ADDENDUM NO. 3

TO: PLANS AND SPECIFICATIONS FOR THE STATE OF MISSOURI

Replace Fire Alarm Systems - Multiple Assets
Western Reception and Diagnostic Correctional Center
St. Joseph, Missouri
PROJECT No.: C2325-01

1 CENTER BUILDING - BASEMENT FLOOR FIRE ALARM PLAN PART-1
SCALE: 3/32" = 1'-0"

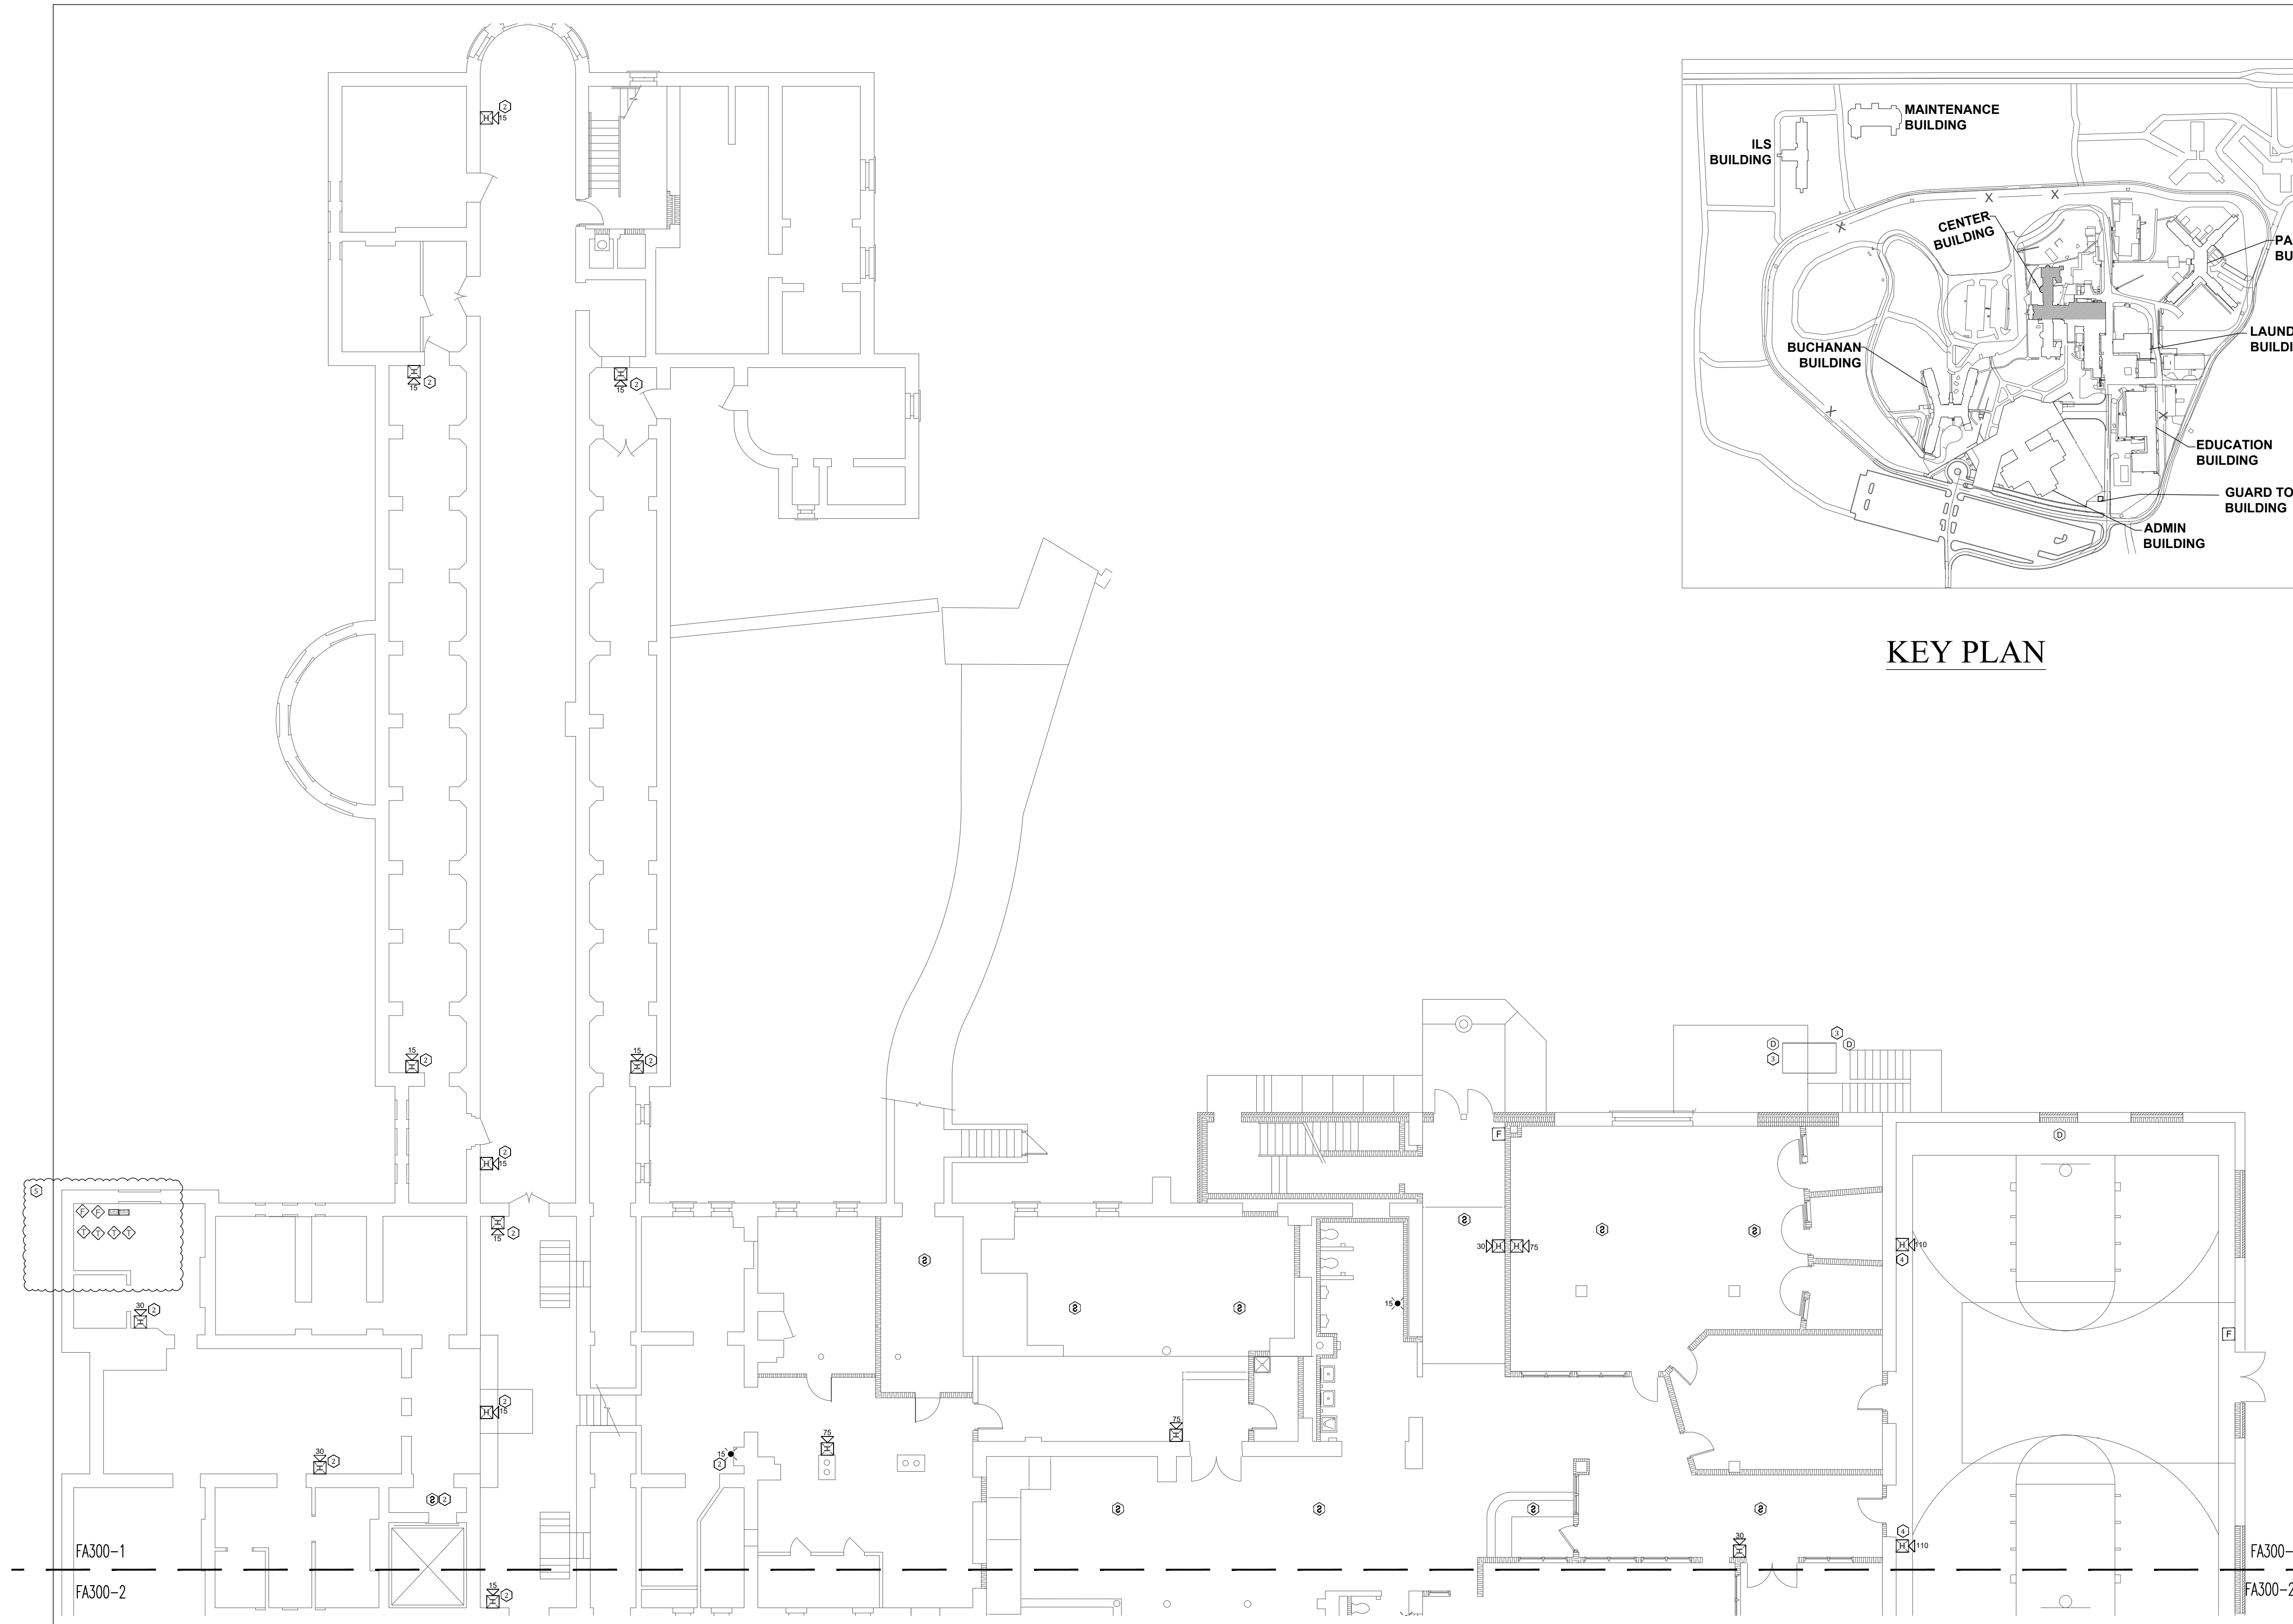
- a. ADDED General Notes.
 - b. See attached revised drawings.
- 8. Sheets FA200-2 and FA300-1
 - a. REVISED Sprinkler monitoring equipment.
 - b. ADDED General Notes.

1 ILS BUILDING - FIRST FLOOR FIRE ALARM PLAN
SCALE: 3/32" = 1'-0"

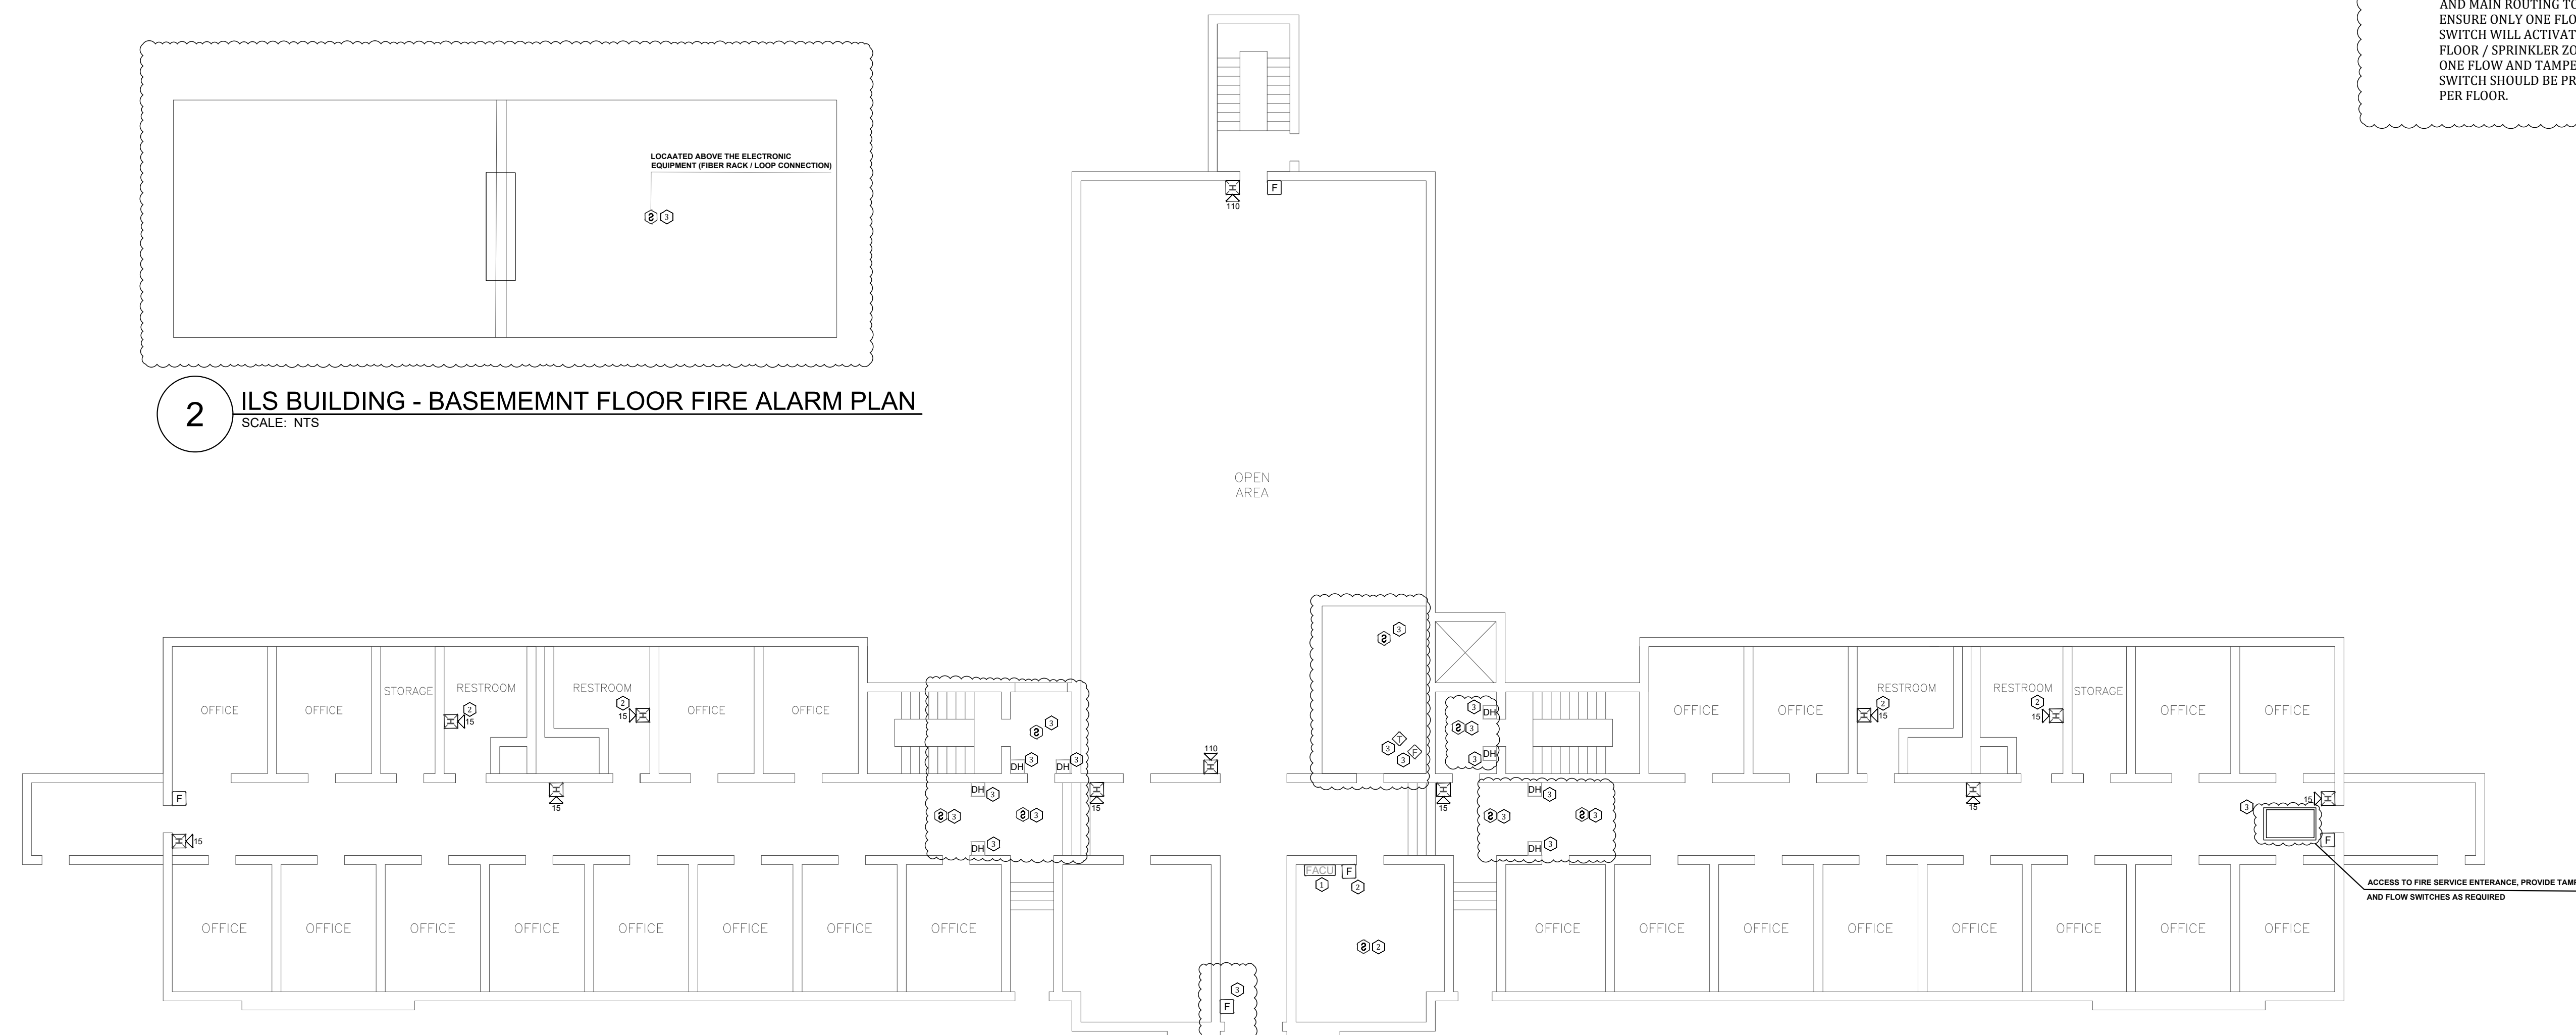
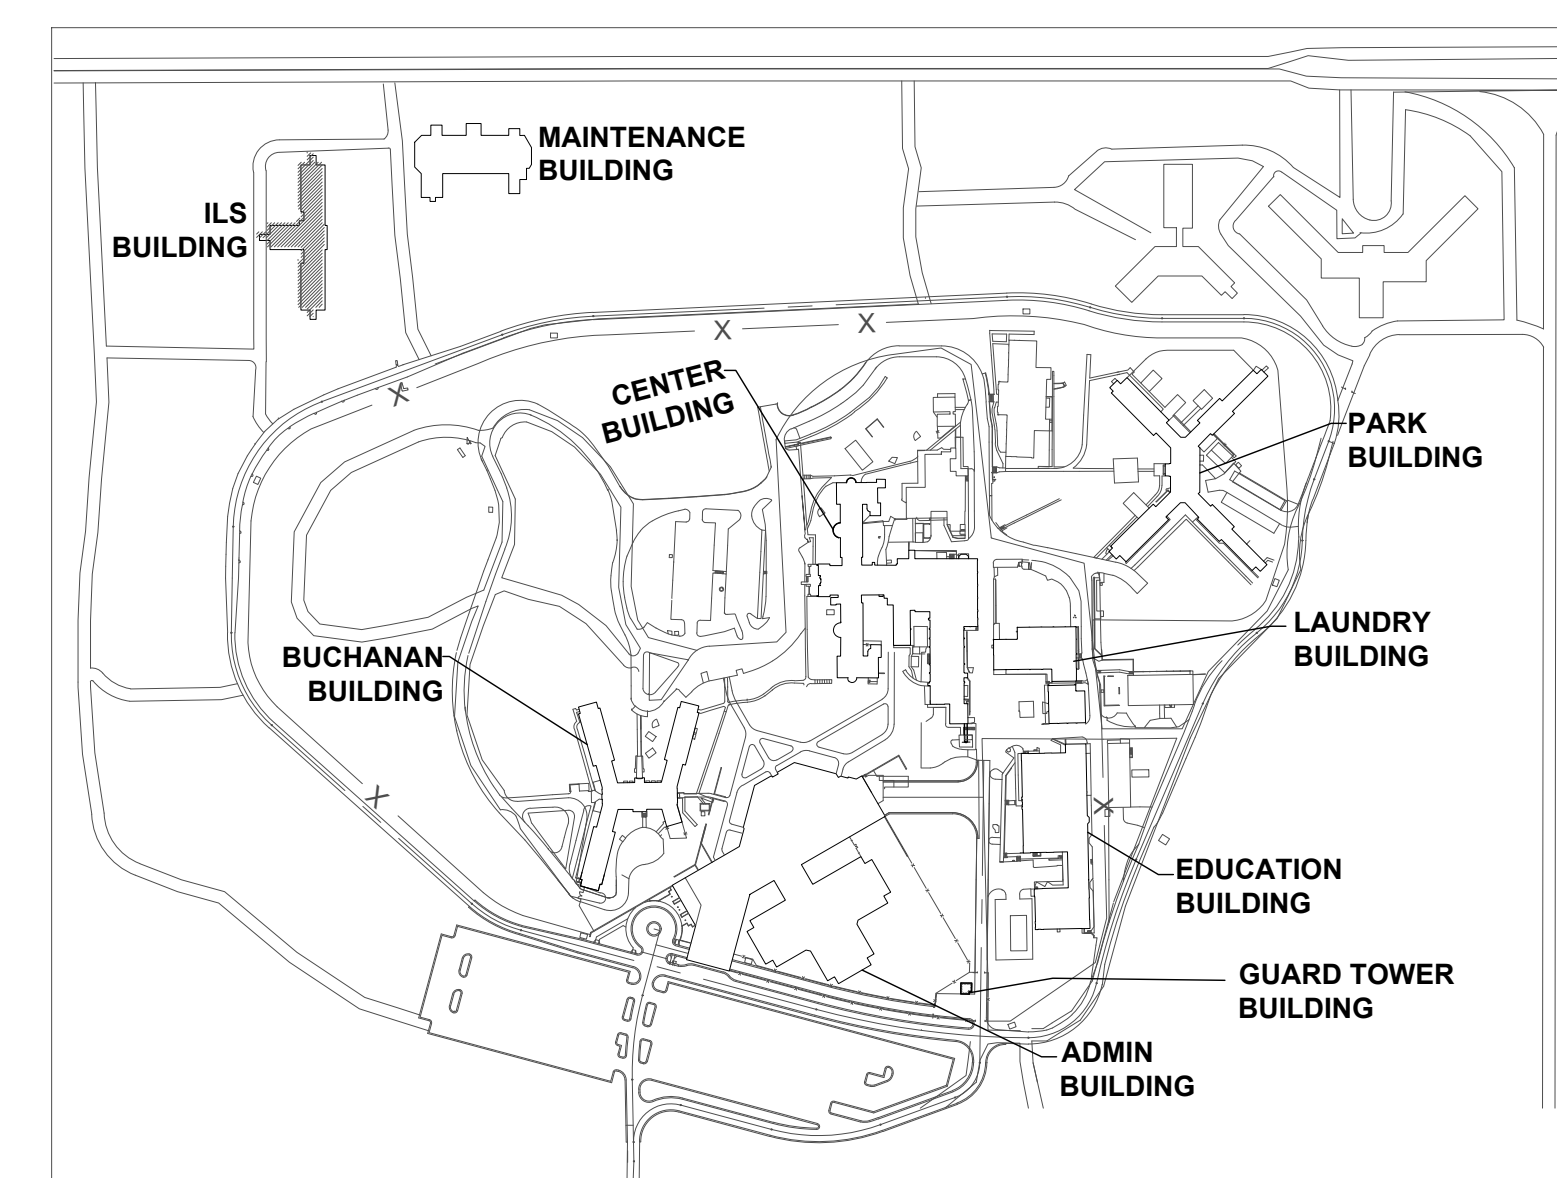
- c. See attached revised drawings.
- 9. Sheet FA300-2
 - a. ADDED Direction for additional detection system in boiler room/powerhouse and General Notes
